UNITED STATES PATENT AND TRADEMARK OFFICE

APPLICATION NO.	FILING DATE	FIRST NAMED INVENTOR	ATTORNEY DOCKET NO.	CONFIRMATION NO.
10/761,162	01/20/2004	David R. Arnold	1566	2557

Office Action Summary

DETAILED ACTION

FIG. 3.

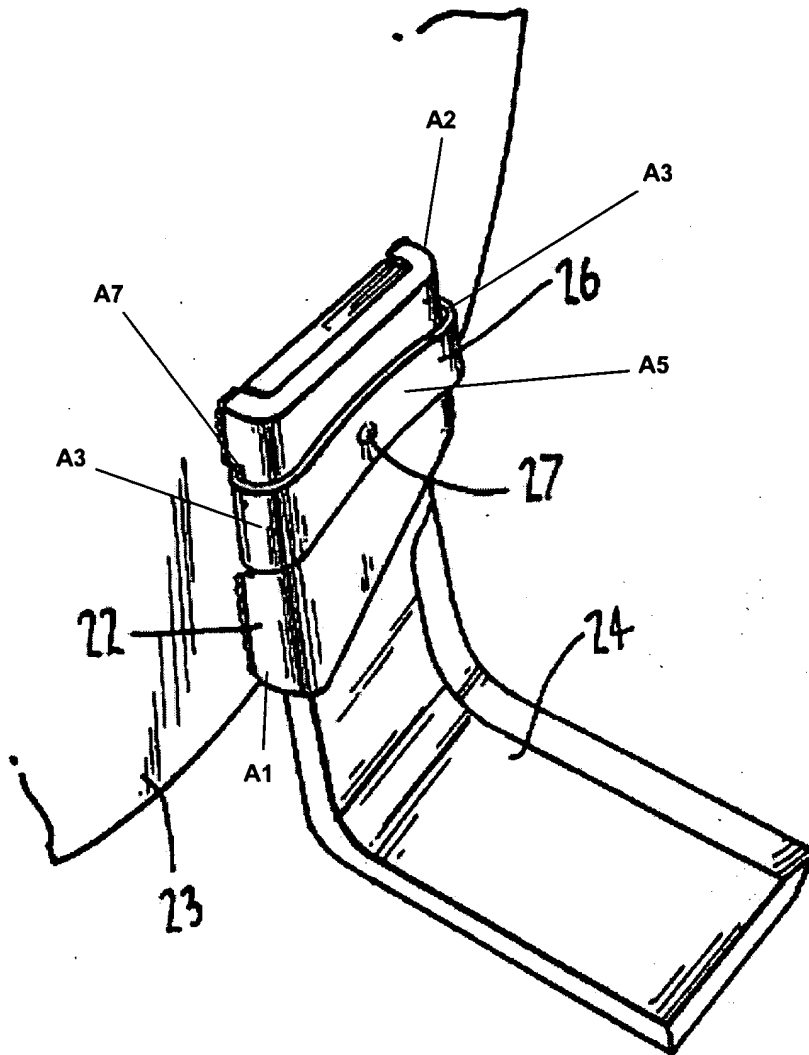
Regarding claim 8, Johnson et al. disclose, in Figures 3, a combination of a fastener **27** and a quick connect anchor. The anchor comprises a plate **22** and a resilient blocking member **26**. The plate **22** has a first side **A1** (see marked-up attachment), a second side **A2**, and a fastener opening (hidden in Figure 3; however, shown in Figure 1, see hole 15). The plate **22** is configured to be placed over the fastener **27**, and configured to be moved in a first direction from a free position to a locked position. The configuration to be moved in a first direction from a free position to a locked position. The resilient block member 26 is movable with the plate from a first position, in a which the resilient member is free from the fastener. The resilient blocking member **26** includes a first leg **A3** and a second leg **A3**. The first leg **A3** is secured to the first side **A1** and the second leg **A3** is secured to the second side **A2**. The resilient blocking member **26** further includes a resilient bridge **A5** spanning a distance between the first leg **A3** and the second leg **A3**, and extending over a portion of the first member 22. The portion having the fastener opening. The first leg and the second leg **A3** are

each respectively received in a snap-fit manner upon the first side and the second side. The first leg and the second leg terminate in a hook (see Figure 1 to see the hook) received within a recess **A7** of each of the plate sides **A1,A2**.

Regarding claim 2, the combination further includes a stop (the head of the pin).

Regarding claim 17, Johnson et al. disclose, in Figures 3, a combination of a fastener **27** and a quick connect anchor. The anchor comprises a first member **22** and a resilient blocking member **26**. The first member **22** has a first side **A1** (see marked-up attachment), a second side **A2**, and a fastener opening (hidden in Figure 3; however, shown in Figure 1, see hole 15). The first member **22** is configured to be placed over the fastener **27**, and configured to be moved in a first direction from a free position to a locked position. The configuration to be moved in a first direction from a free position to a locked position. The resilient block member **26** is movable with the first member from a first position, in a which the resilient member is free from the fastener. The resilient blocking member **26** includes a first leg **A3** and a second leg **A3**. The first leg **A3** is secured to the first side **A1** and the second leg **A3** is secured to the second side **A2**. The resilient blocking member **26** further includes a resilient bridge **A5** spanning a distance between the first leg **A3** and the second leg **A3**, and extending over a portion of the first member **22**. The portion having the fastener opening. The first leg and the second leg **A3** are each respectively received in a snap-fit manner upon the first side

and the second side. The first leg and the second leg terminate in a hook (see Figure 1 to see the hook) received within a recess **A7** of each of the first member sides **A1,A2**.
